RE: RFI RESPONSE | DIGITAL ADVERTISING SIGN | WESTERN DISTRIBUTOR | DA23/4398

Urbis has prepared this submission on behalf of Sydney Trains (**the Applicant**) in relation to DA23/4398 (**the DA**) which seeks consent for the replacement and relocation of an approved third-party digital advertising signage structure (**the proposal**) on the Western Distributor (A4) (**the site**). This submission responds to matters raised in the Department of Planning and Environment (**DPE**) request for additional information (**RFI**) (issued on 17 June 2023), the agency submission from City of Sydney Council (**the City**), and public submissions received throughout the public exhibition period.

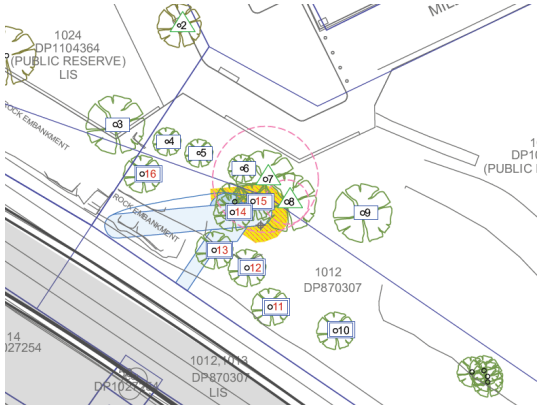
<p>Visual Impacts</p> <p>Please address the following matters:</p> <p>To ensure consistency, for all photomontages:</p> <ul style="list-style-type: none"> Provide an assessment of visual impacts with consideration of trees to be removed. 	<p>The Arborist Report (prepared by Matthew Reed) originally submitted with the DA assessed the extent of trees previously understood on the site. Since the time of the original DA lodgement, this Arborist Report has been superseded. Accordingly, trees marked for potential removal in the Arborist Report (Matthew Reed) should be disregarded.</p> <p>The applicant has commissioned a separate arborist (Naturally Trees) to undertake an Arboricultural Impact Assessment (AIA). This AIA is in preparation and will be submitted to DPE in due course.</p>

DPE Comment	Applicant Response
	<p>Naturally Trees have assessed the construction methodology and have confirmed that Trees # 13, 14, and 15 will require removal. The location of the three trees proposed are removal are identified below.</p> <p>Note. The below plan is taken from the previous Arborist Report and only Tree # 13, 14, and 15 should be considered for removal.</p>  <p>Naturally Trees have assessed that these three trees are of low significance and located within the railway corridor. The trees are identified as 'exempt species' under the City of Sydney Council guidelines and may be pruned or removed at any time by the tree-owner (i.e. the applicant) without approval.</p> <p>As assessed in the Addendum VIA Letter (Appendix A), from a visual impact perspective, the change as a result of the removal of these trees will largely indistinguishable for users of the Western Distributor, and from adjoining streets and close view locations within the public domain. Visually, a consistent band of vegetation will remain, and which will provide screening of the proposal in close view locations including from Bulwara Road and Miller Lane. Aside from the 'pole structure', visibility to the sign will be limited, and removal of the trees will not generate any further significant viewing opportunities or visual prominence.</p>
